PROJECT :
 TSEUNG KWAN O
 AREA 24

TITLE :
 SCHEMATIC DIAGRAM OF
 CADD SYSTEM

DATE	16-7-96	SCALE	N.I.S.
DRAWN BY :	GARY LEUNG	CHECKED BY :	S.Y. LAU
DRAWING NO. :	AS-33200-ELV-517-01

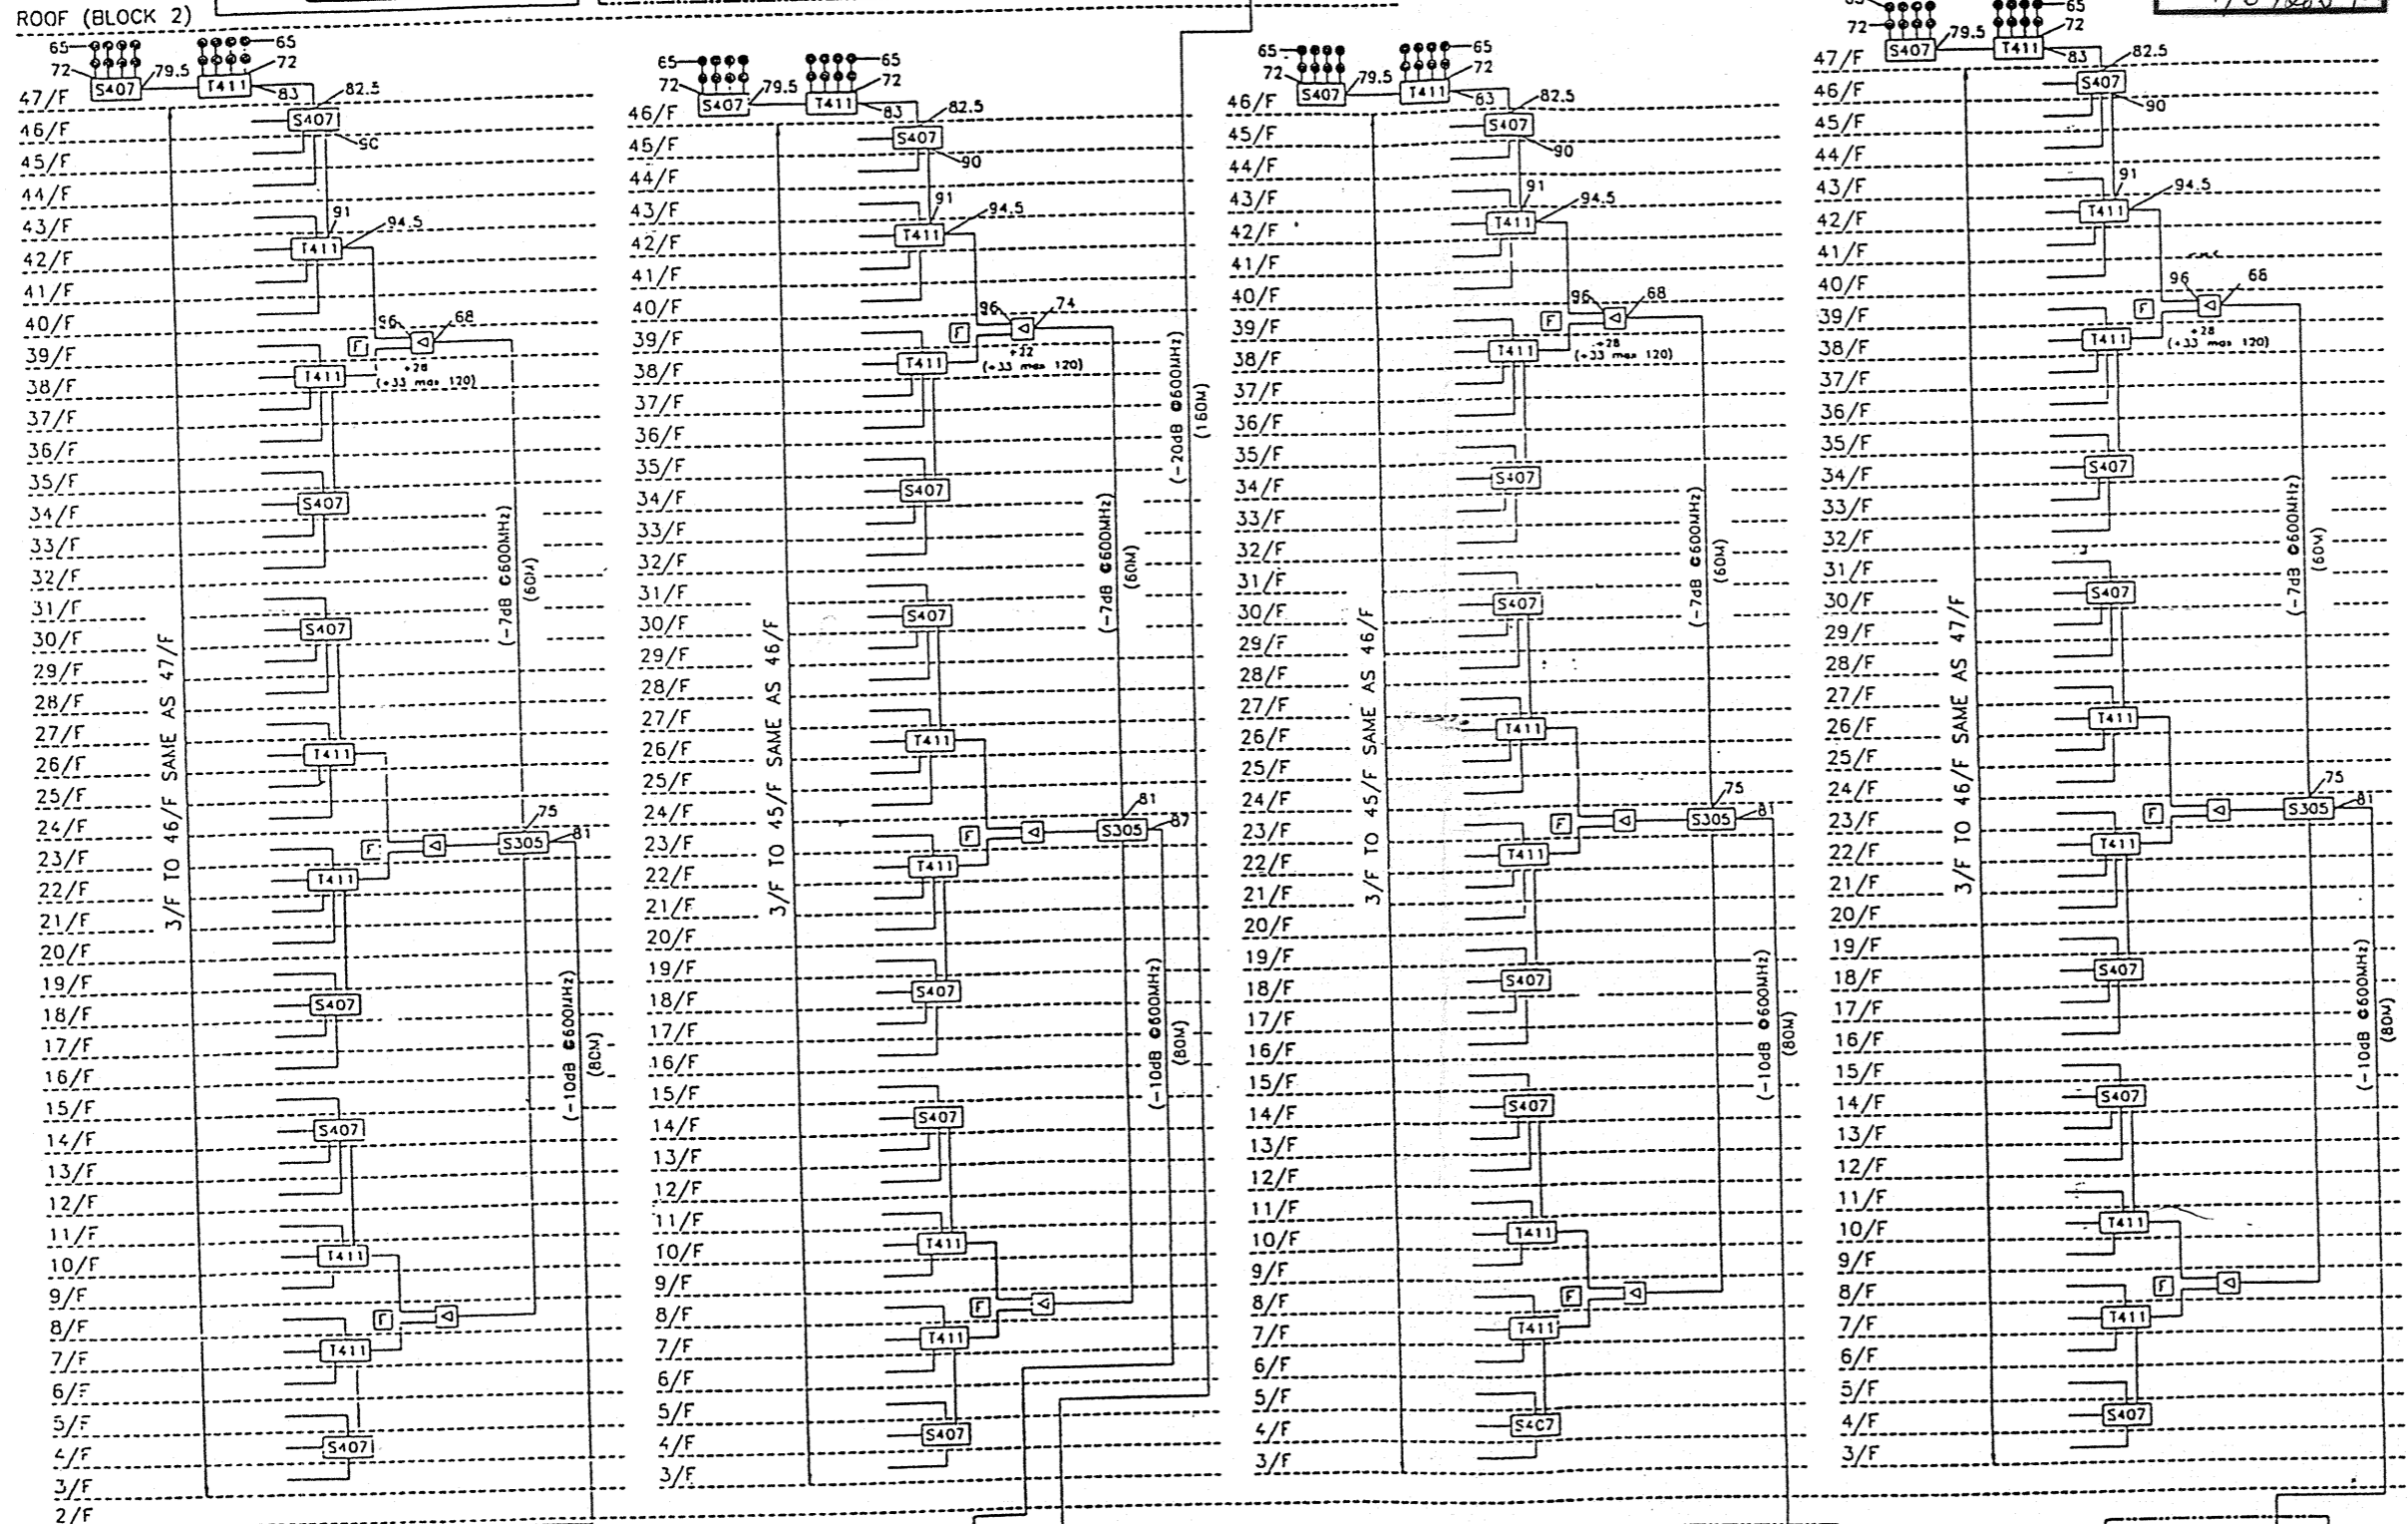
ASSOCIATED ENGINEERS
 TRIDANT ENGINEERING CO., LTD
 403, NEW WORLD CENTRE, 205 SALISBURY ROAD,
 HONG KONG
 Date: 29/9/98
 Engineer's review is for general compliance with the design concept and
